**PLANNING COMMISSION STAFF REPORT**  
MAJOR MODIFICATION OF CRESTVIEW CROSSING PUD/CUP  
FILE NO. MAMD323-0001 - HWY 99W AND E CRESTVIEW DRIVE

**FILE NO:** MAMD323-0001

**REQUEST** Request for a major modification of a previously approved Planned Unit Development (PUD18-0001) and Conditional Use Permit (CUP18-0004) to construct 196 multi-family dwelling units in eight multi-family structures.

**C202**

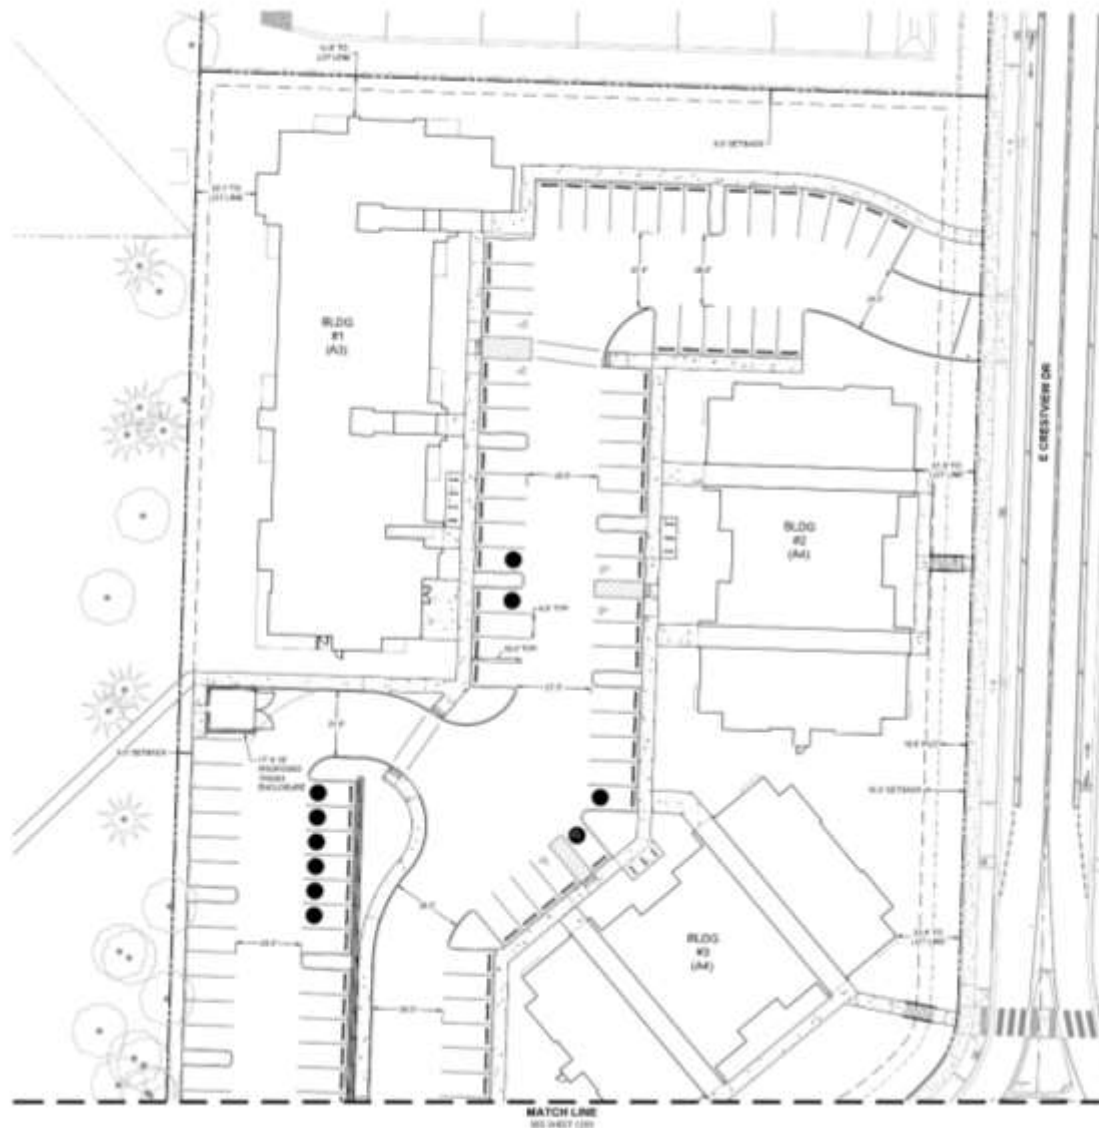
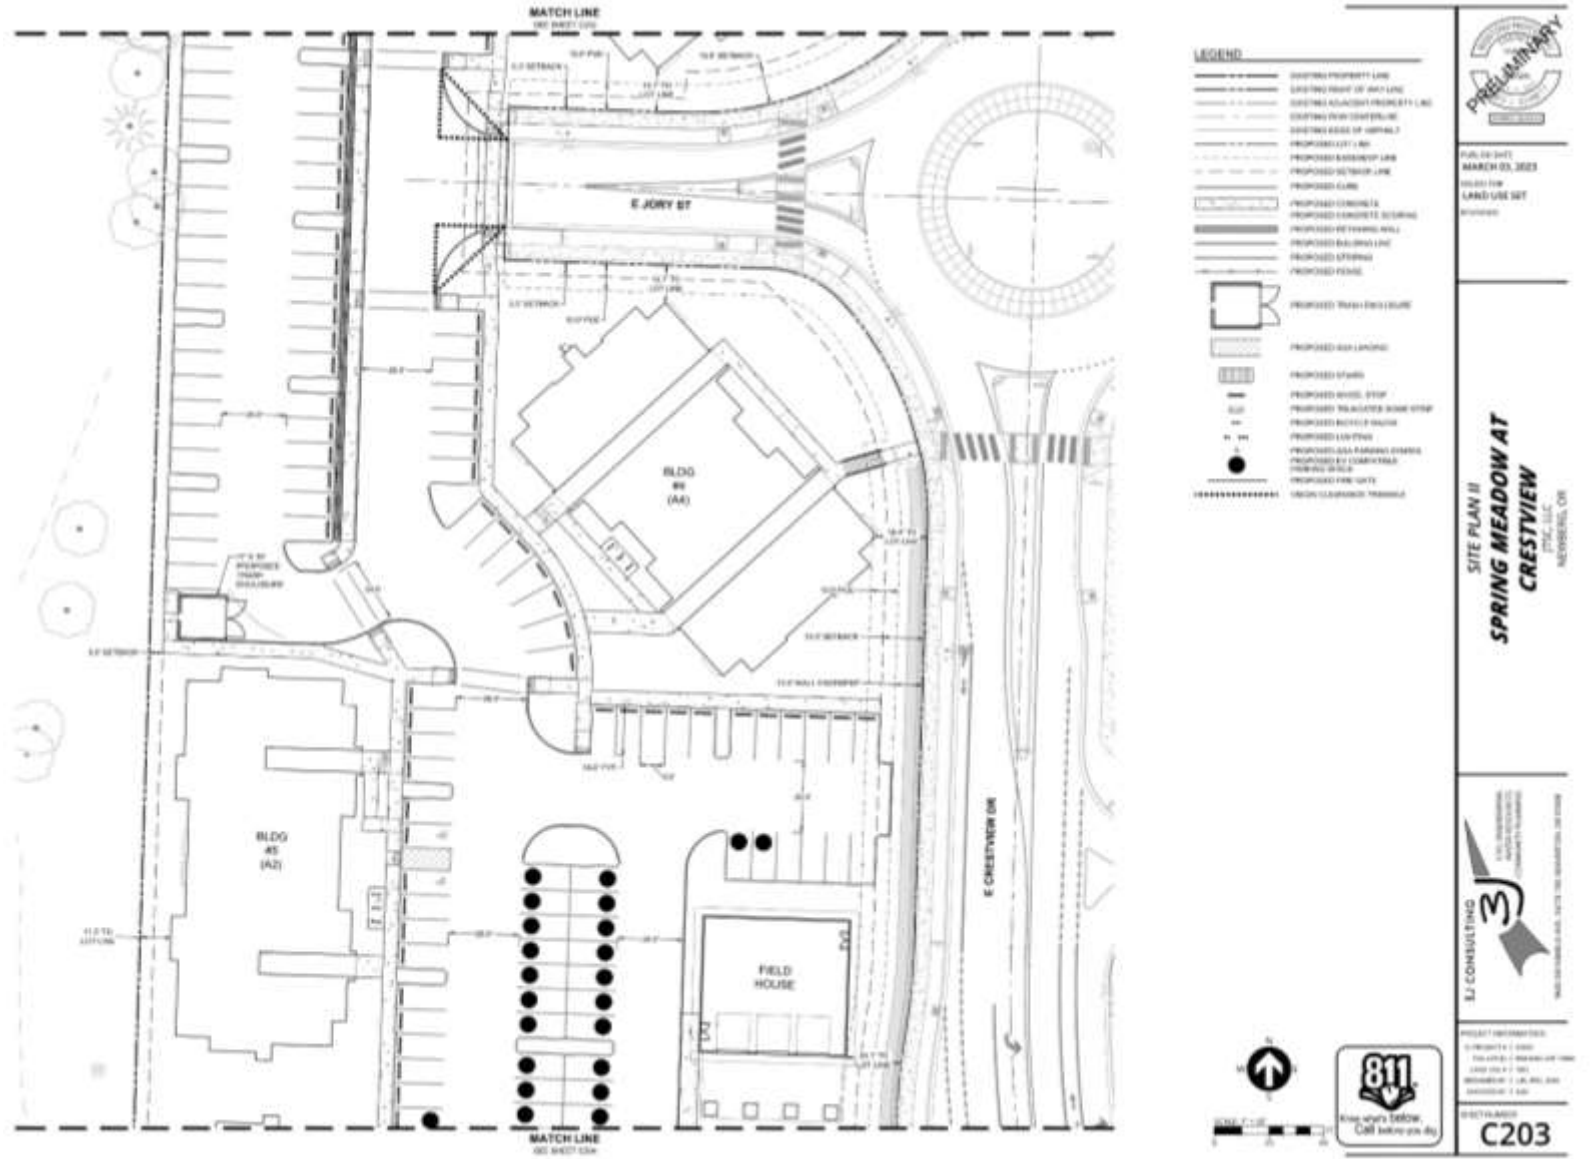
- b. City Manager: Reviewed, no conflict.
- c. Community Development Director: Reviewed and provided the following comments:
  1. *Building #7 more than 7 spaces in a row.*
  2. *Check lighting plan for compliance.*
  3. *Check density point calculations.*
  4. *PUD Homeowners Association.*
- d. Finance Department: Reviewed, no conflict.
- e. Newberg-Dundee Police Department: Reviewed, no conflict.
- f. Public Works, Wastewater Treatment Plant: Reviewed, no comment.
- g. Public Works, Water Superintendent: Reviewed, no comment.
- h. Public Works, Senior Engineer: Reviewed. Comments were integrated into the staff report including findings and conditions of approval.
- i. Oregon Department of Transportation (ODOT): Reviewed, provided comments stating:

Because the line of parking stalls located immediately north of Building #7 possesses 8 parking stalls in a continuous row it exceeds the standard identified in NMC 420.010(B)(3)(h) which states that no more than seven parking spaces may be grouped together without an island separation unless otherwise approved by the director. The Applicant shall modify the proposed parking configuration to comply with NMC 15.420.010(B)(3)(h); provide a continuous landscaped strip, with a five-foot minimum width, which runs perpendicular to the row of parking spaces (see NMC, Title 15, Appendix A, Figure 13); or provide tree planting landscape islands, each of which is at least 16 square feet in size, and spaced no more than 50 feet apart on average, within areas proposed for back-to-back parking (see NMC Title 15, Appendix A, Figure 14).

1. The Applicant shall modify the proposed parking configuration to comply with NMC 15.420.010(B)(3)(h); provide a continuous landscaped strip, with a five-foot minimum width, which runs perpendicular to the row of parking spaces (see NMC. Title 15, Appendix A, Figure 13); or provide tree planting landscape islands, each of which is at least 16 square feet in size, and spaced no more than 50 feet apart on average, within areas proposed for back-to-back parking (see NMC Title 15, Appendix A, Figure 14).
